## Product Change Notification / GBNG-02EIPE100

CCB 6067 Final Notice: Qualification of STAR as an additional final test site for MICRF221AYQS and MICRF221AYQS-TR catalog part numbers (CPN) available in 16L QSOP (3.90mm) package.

**PCN #: GBNG-02EIPE100**

**CCB 6067**  
**Pre and Post Change Summary**  
**PCN #: GBNG-02EIPE100**

# Pre and Post Change – Tape and Reel

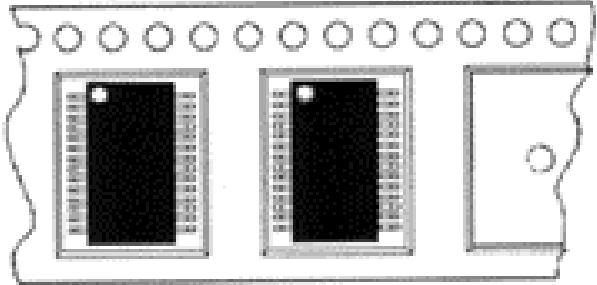
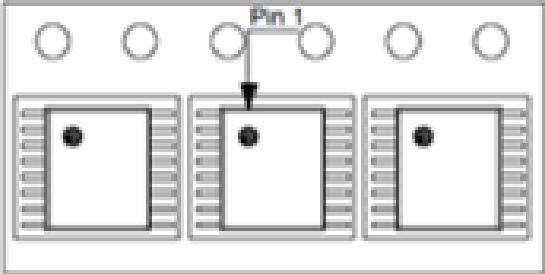
UNIS	STAR
BQM (Base Quantity Multiple)	2500 per reel	2500 per reel
Pin 1 orientation	 <p>Quadrant 1</p>	 <p>Quadrant 1</p>

# Pre and Post Change – Plastic Reel

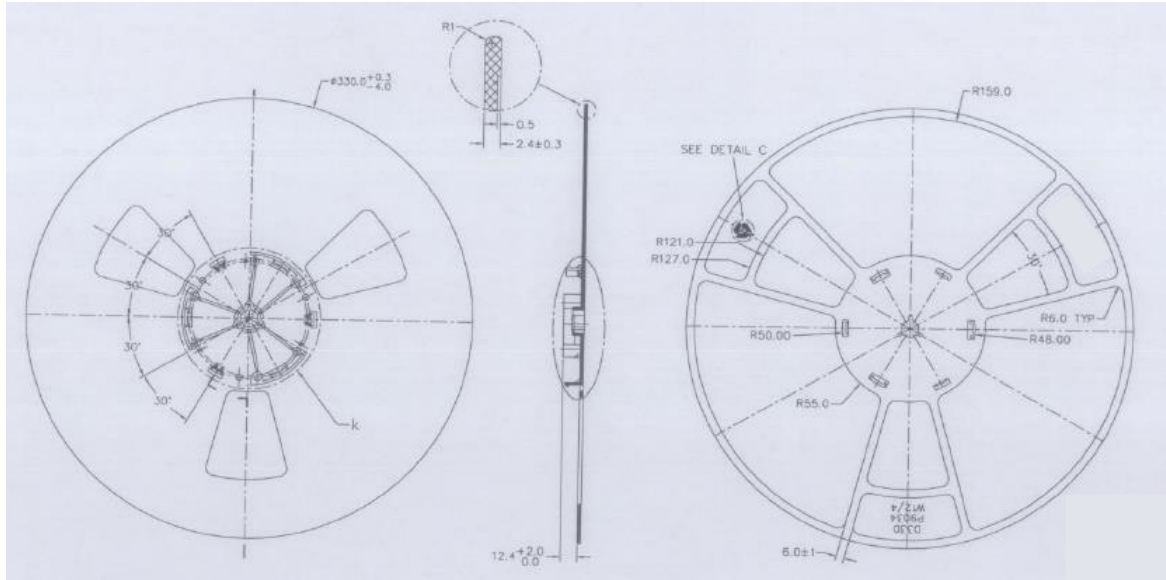
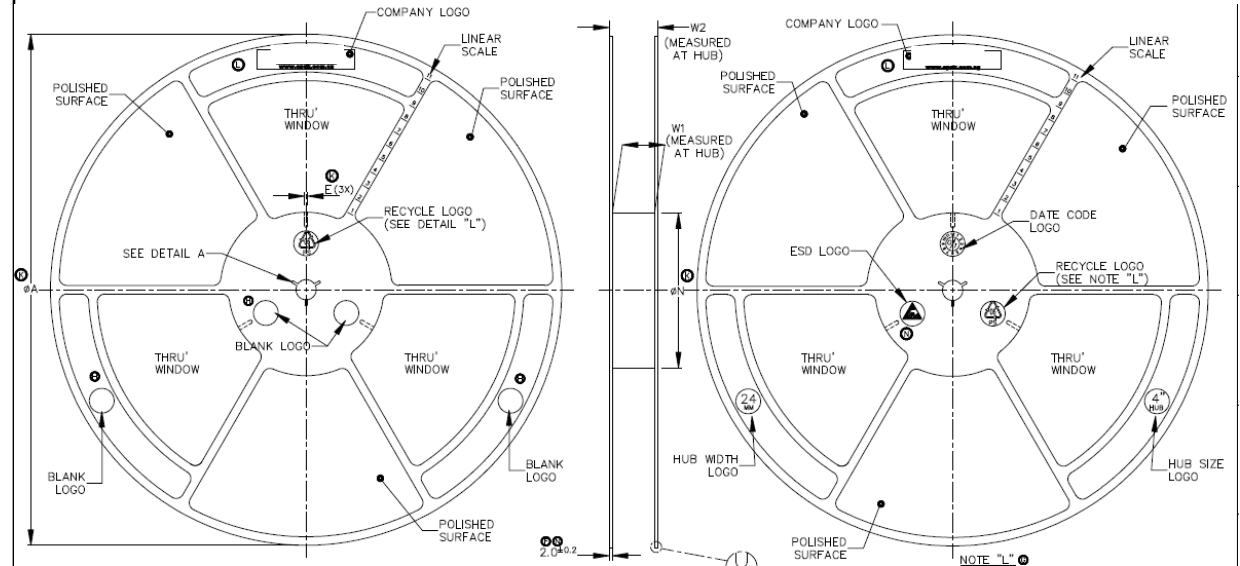
No dimension change.

# Pre and Post Change – Carrier Tape

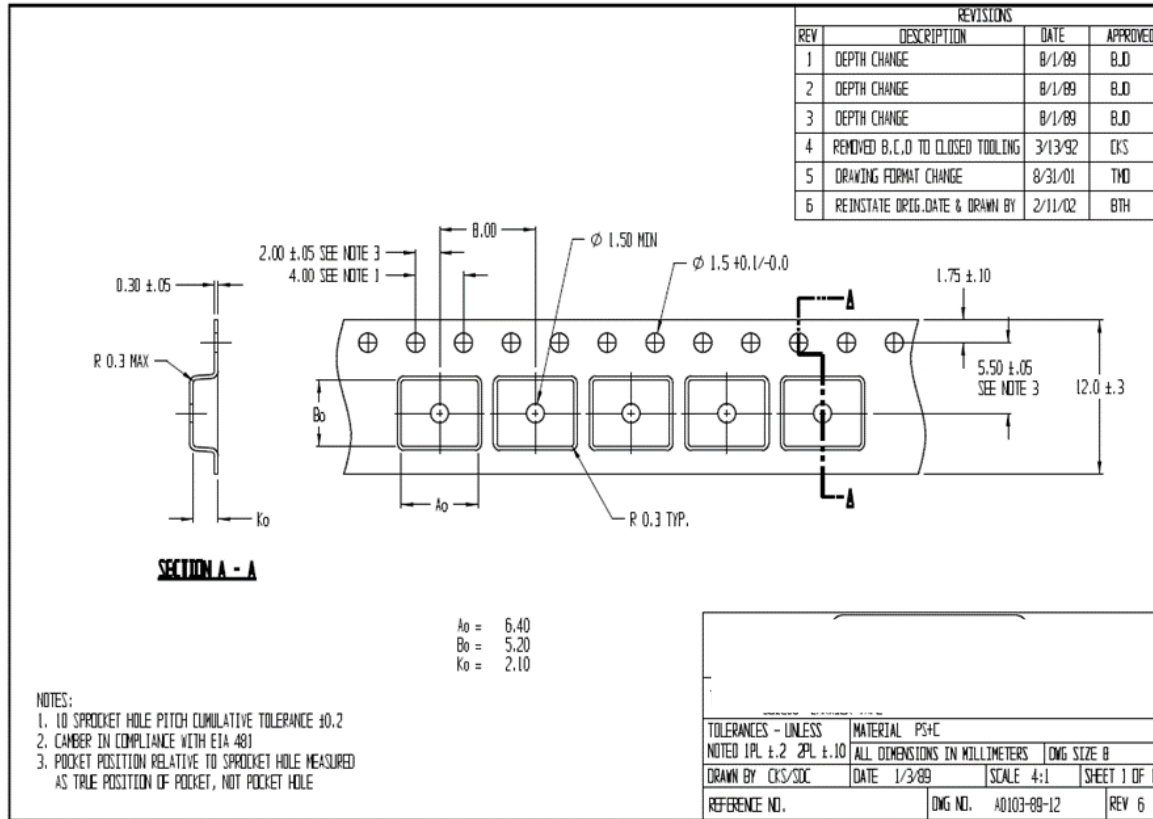
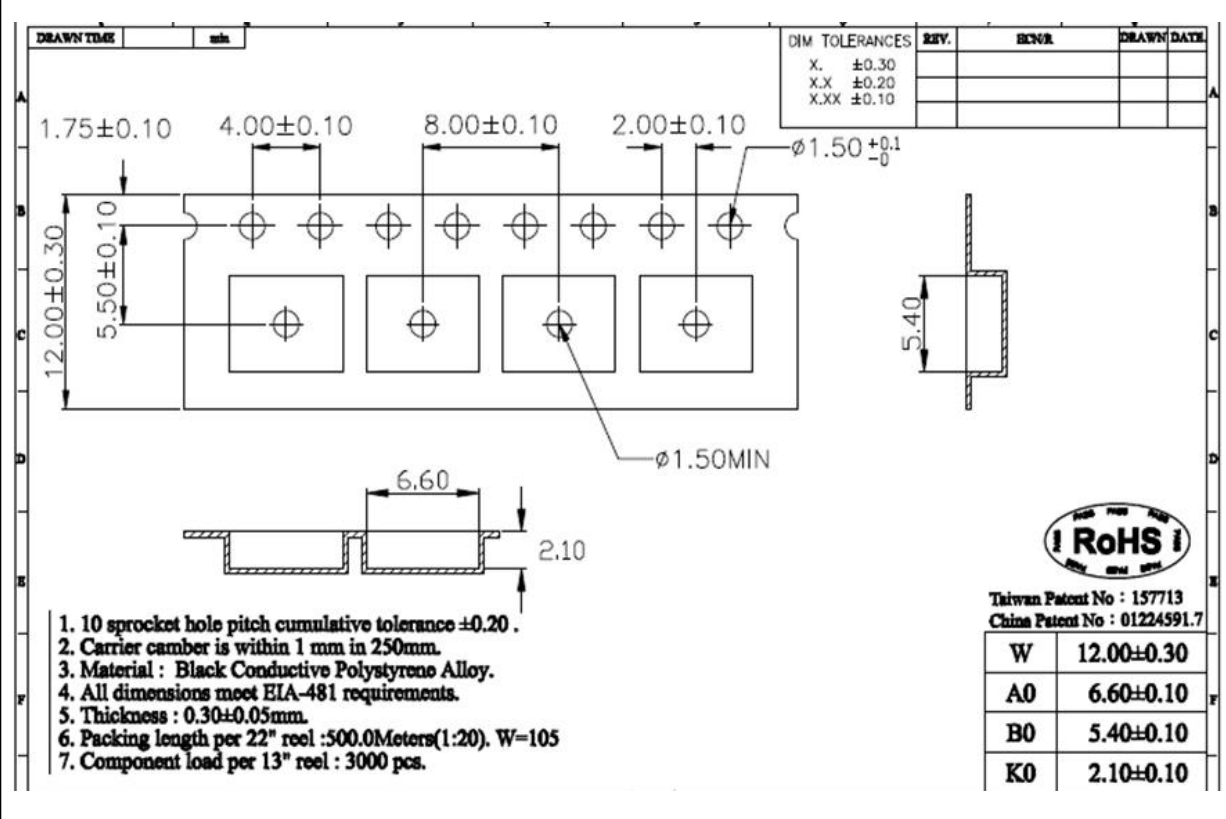
Plant	W (mm.) $\pm 0.3$ or Specific	P (mm.) $\pm 0.1$ or Specific	A <sub>0</sub> $\pm 0.1$ or Specific	B <sub>0</sub> $\pm 0.1$ or Specific	K <sub>0</sub> $\pm 0.1$ or Specific
UNIS	12	8	6.40	5.20	2.10
STAR	12	8	6.60	5.40	2.10

# Pre and Post Change – Cover Tape

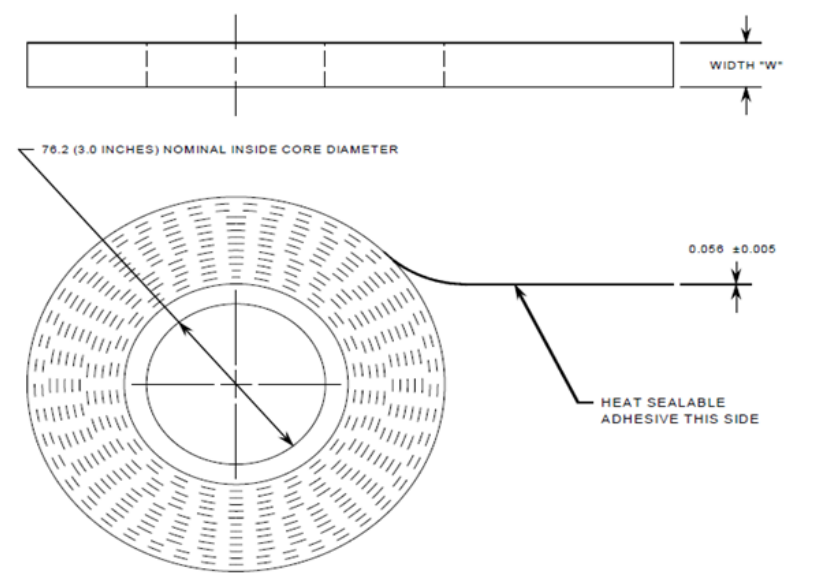
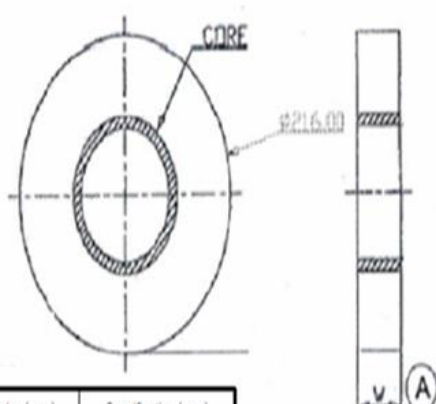
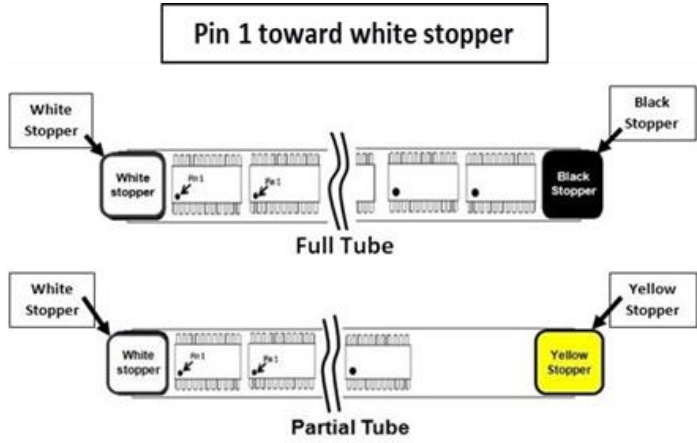
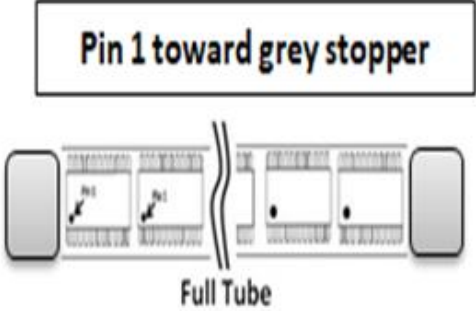
Plant	Carrier Tape Width	Cover Tape Width	Thickness	Color	Sealing mythology
UNIS	16mm	13.3 +/-0.1mm	0.056+/-0.005	Clear	Heat sealing
STAR	16mm	13.3 +/-0.2mm	0.050+/-0.005	Clear	Heat sealing

# Pre and Post Change – Tube

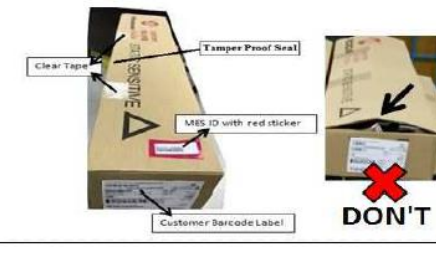
UNIS	STAR
BQM (Base Quantity Multiple)	98 units	98 units
Pin 1 orientation	<p>Pin 1 toward white stopper</p> 	<p>Pin 1 toward grey stopper</p> 
Tube Color	Clear tube	Clear tube
Plug Color	Full Tube: White – Black Partial Tube: White – Yellow	Grey-Grey
